WORKSHOP BULLETIN

RE:	PRODUCT
HANDBRAKE	P
140, 164, 1800	GROUP
	55
DATE	NO.
April, 1970	8

Improved handbrake, 140, 164 and 1800

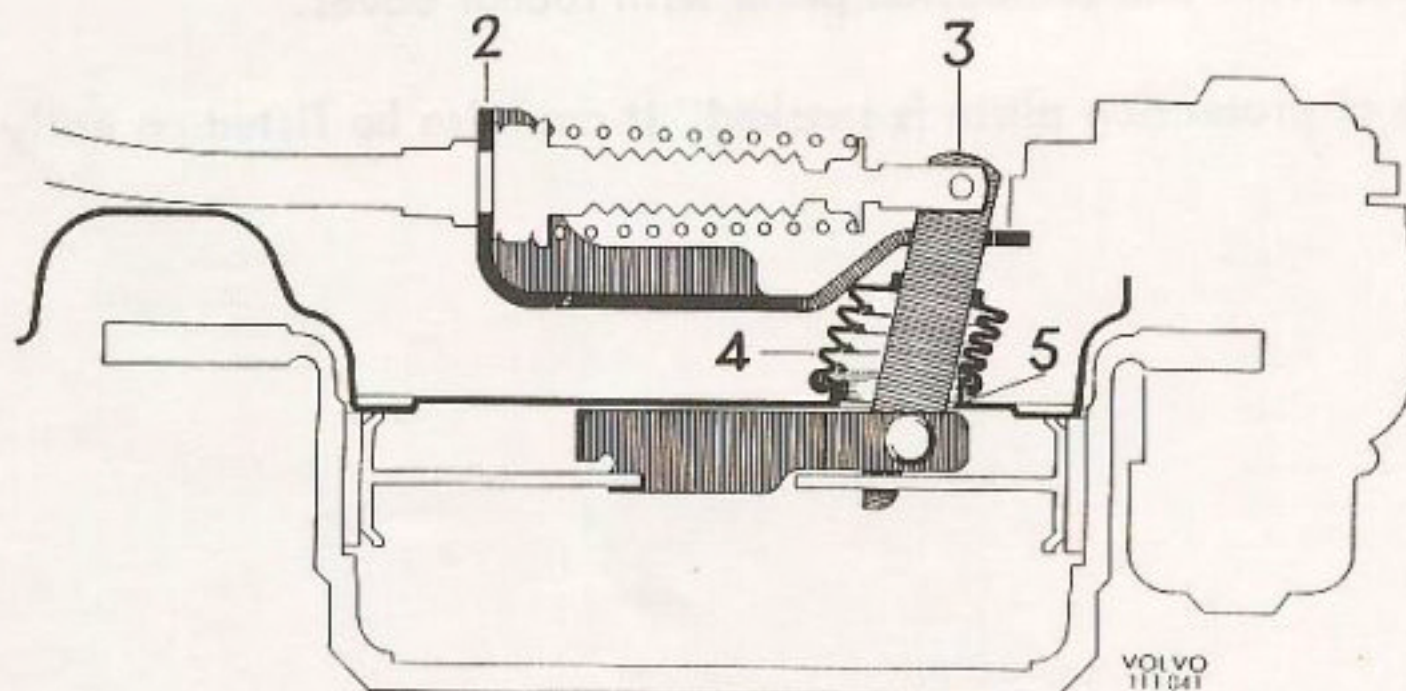
1. New type of pawl and ratchet segment on the 140 and 164.
2. New type of bracket for cable.
3. Lever with larger movement.
4. Rubber cover for lever introduced and cover plate removed.
5. Guard plate with attachment for rubber cover.

2. Bracket

3. Lever

4. Rubber cover

5. Guard plate

1. Only the new type of pawl and ratchet segment are being stocked. If, for example, you are replacing the pawl on older vehicles, you must also replace the ratchet segment.
2. Both the old and new types of bracket are stocked. The new bracket should be used for the new lever.
3. Both the old and new levers are stocked. The new lever must have the new bracket with it. Both sides have the same type of lever.
4. The rubber cover can only be mounted on the new protection plate. When replacing this cover, the rear wheel brake unit must be dismantled. The cover plate should not be fitted between the lever link and protection plate with rubber cover.
5. Only the new type of protection plate is stocked. It can also be fitted on early prod. vehicles.
